SERVICE LETTER NUMBER 136			
TITLE: 3000/3450 NOSE BOX - FINGER TAB INSTALLATION			
BY: J. Sortor	AIRCRAFT MAKE/MODEL(S):	FLOAT MODEL(S):	NOTE(S):
APP: D.Garrett	Cessna: 180, 182, 185,206	3000 Amphibian	OPTIONAL COMPLIANCE
DATE: 7/8/2013	Maule: M-6-235; M-7-235; M-7-235B;	3450 Amphibian	S/L P/N 1005835
REV: B	M-7-235C; M-7-260; M-7-260C; M-7-420A; M-7-4Z0AC; MT-7-235; MT-7-260; MX-7-235		ECO--23245

SERVICE LETTER P/N: 1005835

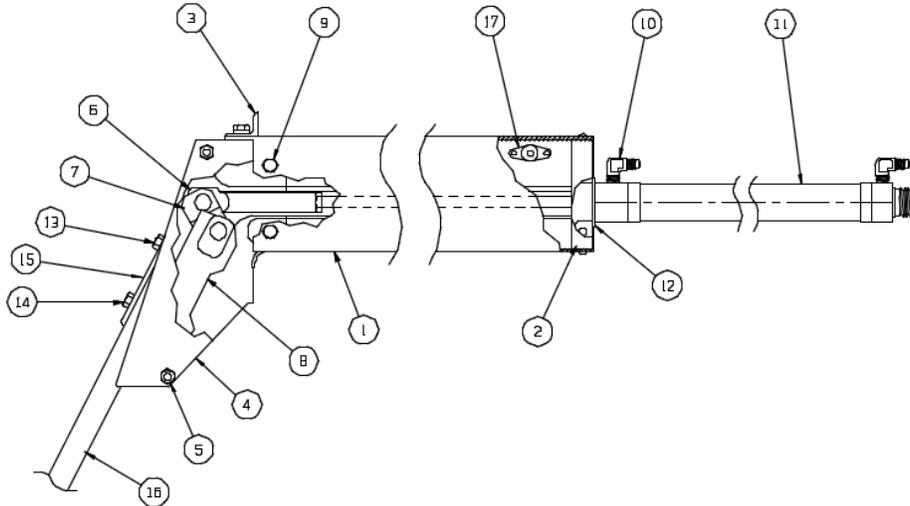
4. Scrape sealant away and inspect nose bulkhead for cracks, especially near lower bolt attachment. If the bulkhead is cracked it must be replaced (PN 30A01155-029).

5. Unbolt nose track PN 21A07349-003 & -004 (Item 4 below) from nose box PN 30A07323-002 (Item 1 below) and inspect mating holes.

6. If holes are out of round (which is very likely if you can see flexing of the nose bulkhead in step 1) it is acceptable to upsize lower mating nose box and nose track holes (Item 9 above) from $\frac{1}{4}$ " to $\frac{5}{16}$ ".

Parts List			
ITEM	QTY	PART NUMBER	DESCRIPTION
1	1	30A07323-002	NOSE BOX, 3000 FLOAT
2	1	21A07349-003	END, NOSE GEAR TRACK LEFT
3	1	1005834	SPACER, FINGER PATCH
4	1	1005833	FINGER PATCH

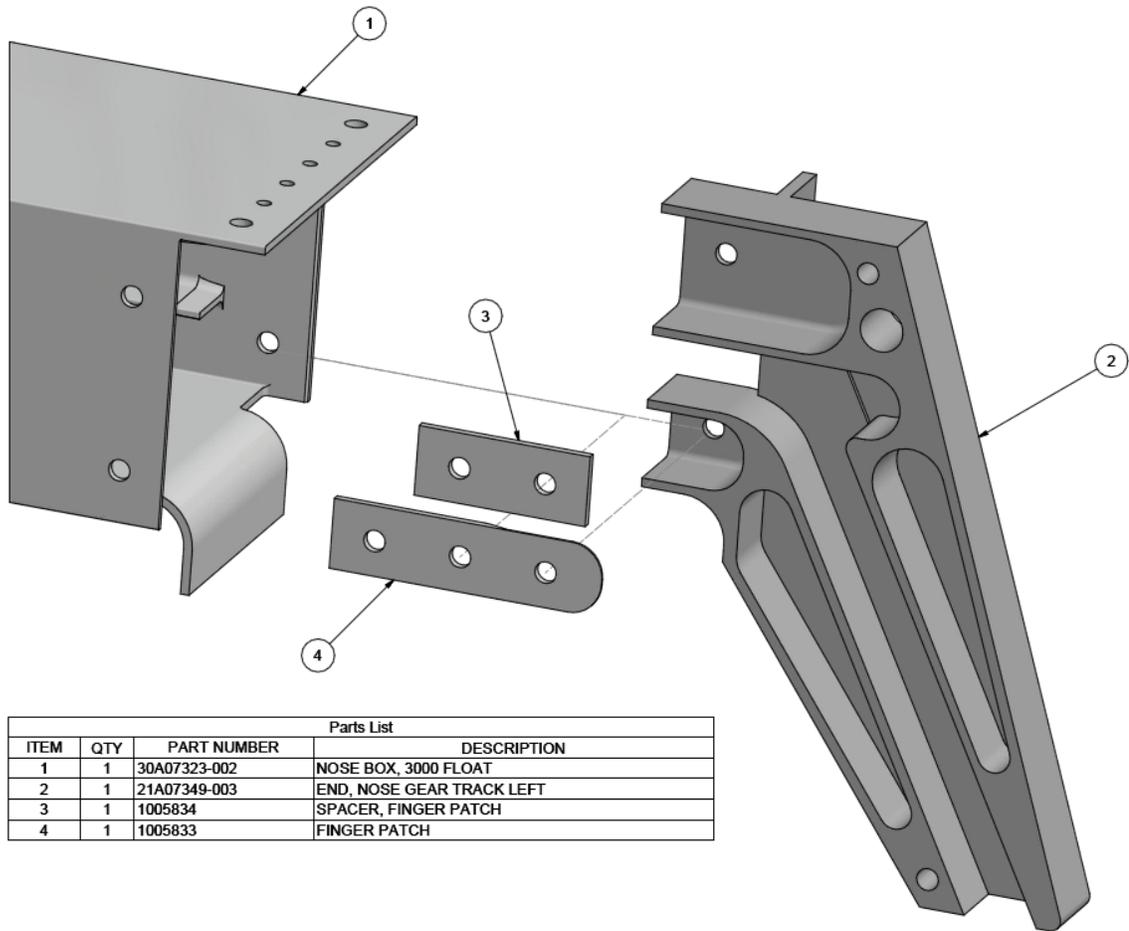
7. **Finger Patch Installation.** To install the finger patch proceed with the following steps:

8. Fit Finger Patch PN 1005833 to Nose Track PNs 21A07349-003 & -004 by placing into bolt recess and ensuring that the patch sits flat to bolt hole face. This part should be a tight fit, remove any material on finger patch that keeps it from sitting flat.

9. Install bolt through finger patch (1005833), Nose Track (21A07349-003), and Nose Box (30A07323-002). Tighten nut to verify a good fit. Note: if the lower mating hole was opened to 5/16" the hole in the finger patch must also be opened up to 5/16"

13. Once the finger patches are glued to the nose tracks, reinstall nose tracks to nose box and transfer the two additional holes (2 each side) from the finger patch to the nose box. If the nose box/nose track mating hole was opened to 5/16" it is acceptable to open remaining finger patch and spacer (1005834) holes to 5/16" to keep mating hardware consistent.

14. Reassemble nose box, nose tracks, and finger patch with appropriate length AN4 or AN5 hardware as appropriate.
 15. Reinstall nose box assembly into float
